# Part Number Update

Bulletin No: PNU-138

Subject: **Bendix® Rear Axle Module (RAM) Replacement**

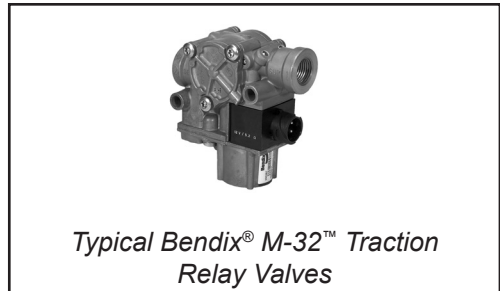
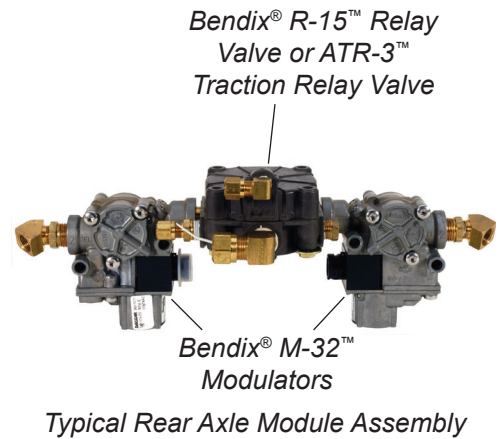
Rear Axle Module Service Assemblies will no longer be available as a complete assembly. When servicing the Bendix® RAM replace the individual components as needed.

\* When servicing the modulators on these assemblies, replace both modulators at the same time.
